Contract #: 04-0120F4Cty: SF/ALA Rte: 80 PM: 13.2/13.9File #: 69.25B**QUALITY ASSURANCE -- NON-CONFORMANCE REPORT****Location:** Changxing Island, Shanghai, China**Report No:** NCR-000830**Prime Contractor:** American Bridge/Fluor Enterprises, a JV**Date:** 31-Aug-2010**Submitting Contractor:** Zhenhua Port Machinery Company, Ltd (ZPMC), Changxing Island**NCR #:** ZPMC-0792**Type of problem:**

Reference Description: Missed UT Indication discovered by QA on FB3329A (Lift 14W)**Description of Non-Conformance:**

Reference Description: Missed UT Indication discovered by QA on FB3329A (Lift 14W)

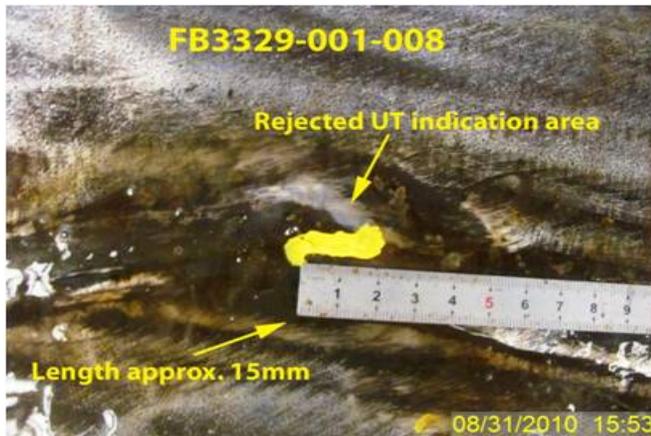
During the Quality Assurance Ultrasonic Testing (UT) review of welds located on Orthotropic Box Girder (OBG) Floor Beam FB3329A, this Quality Assurance Inspector (QA) discovered the following issues:

- One longitudinal linear Class "A" rejectable indication measuring approximately 15mm in length.
- The indication dbS rating is a +7.
- Material thickness is 18/22mm.
- The depth of the indication is approximately 11.2mm.
- The weld is identified as FB3329-001-008.
- The weld is Complete Joint Penetration (CJP) butt joint, joining floor beam web X4850B to floor beam web X4848A.
- The weld is designated as Seismic Performance Critical Material (SPCM).
- The indication is clearly marked on or near the weld.
- The Y distance for this indication is 780 mm from edge of the joint.
- Floor Beam FB3329A is located at bay 2.

The Notice of Witness Inspection (NWIT) No. is 006542. The indication is located within an area previously tested and accepted by ZPMC Quality Control (QC) personnel. As per the contract documents, ZPMC's QC personnel are required to perform 100% UT inspection of this weld.

For details see the attached Photo

ZPMC has repaired the indication and is providing NDT after to show it is acceptable. ZPMC QA has written an internal NCR to identify and reprimand the inspector for missing the indication and make him aware to prevent future occurrences. Based on this ZPMC is requesting closure of this NCR.

The proposed resolution is acceptable. This NCR is considered closed.

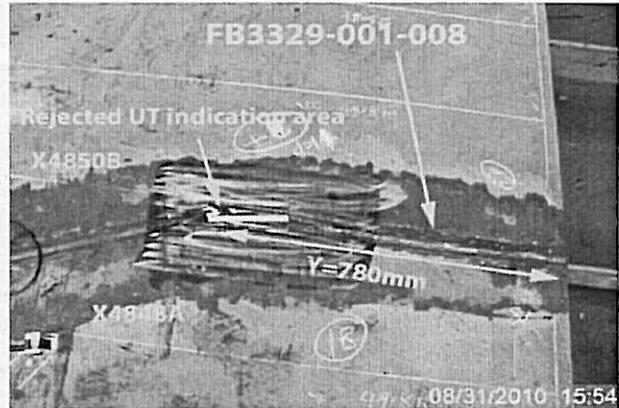
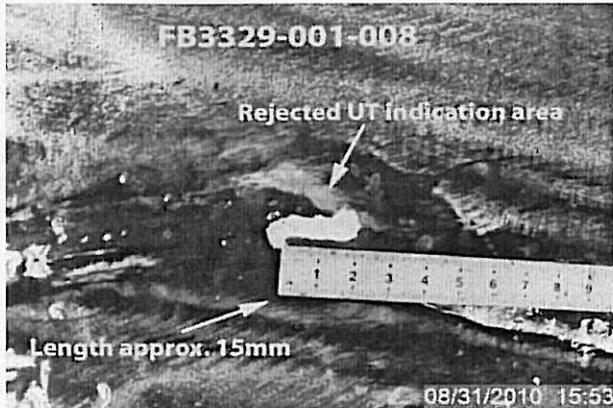
During the Quality Assurance Ultrasonic Testing (UT) review of welds located on Orthotropic Box Girder (OBG) Floor Beam FB3329A, this Quality Assurance Inspector (QA) discovered the following issues:

- One longitudinal linear Class "A" rejectable indication measuring approximately 15mm in length.
- The indication dbS rating is a +7.
- Material thickness is 18/22mm.
- The depth of the indication is approximately 11.2mm.
- The weld is identified as FB3329-001-008.
- The weld is Complete Joint Penetration (CJP) butt joint, joining floor beam web X4850B to floor beam web X4848A.
- The weld is designated as Seismic Performance Critical Material (SPCM).
- The indication is clearly marked on or near the weld.
- The Y distance for this indication is 780 mm from edge of the joint.
- Floor Beam FB3329A is located at bay 2.

The Notice of Witness Inspection (NWIT) No. is 006542. The indication is located within an area previously tested and accepted by ZPMC Quality Control (QC) personnel. As per the contract documents, ZPMC's QC personnel are required to perform 100% UT inspection of this weld.

For details see the attached Photo

焊缝返修位置示意图:

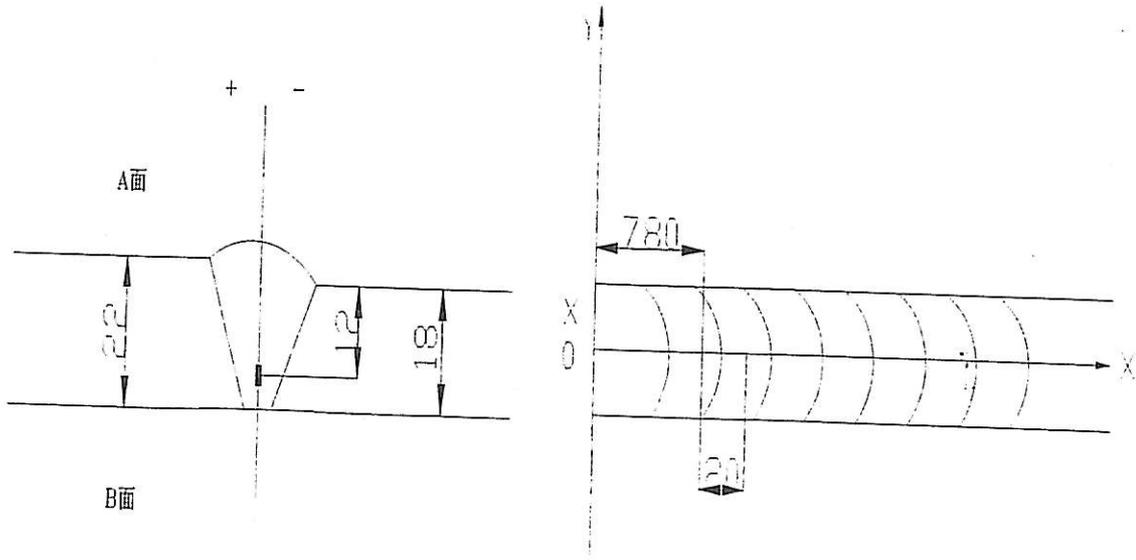
焊缝缺陷描述：(普通UT探伤发现的缺陷长度小于最大允许长度)
 (Description of welding discontinuity): Rejected indication found by ultrasonic inspection is less than the maximum allowance aggregate length.

焊缝编号为: FB3329-001-008

- 1、焊道未及时处理干净。
1. Did not clear the weld pass completely in time.

1. 从缺陷距离端面较近一侧 ($D \leq 0.65T$, D为缺陷深度, T为板厚) 采用碳刨或打磨的方法去除焊缝缺陷;
 2. 参照返修焊接工艺规程 (WPS) 准备正确的接头型式, 预热和焊接;
 3. 将修补区域打磨到与母材或邻近焊缝平齐;
 4. 根据批准的车间图纸检查焊缝.
-
1. Gouge or grind from nearer side from metal edge ($D \leq 0.65T$, "D" is depth of defects, "T" is thickness of metal) to remove all defects;
 2. Follow repair WPS for joint preparation, preheat, and weld deposit;
 3. Grind the repaired area flush with base metal or the adjacent weld;
 4. Check the welds according to the working drawings.
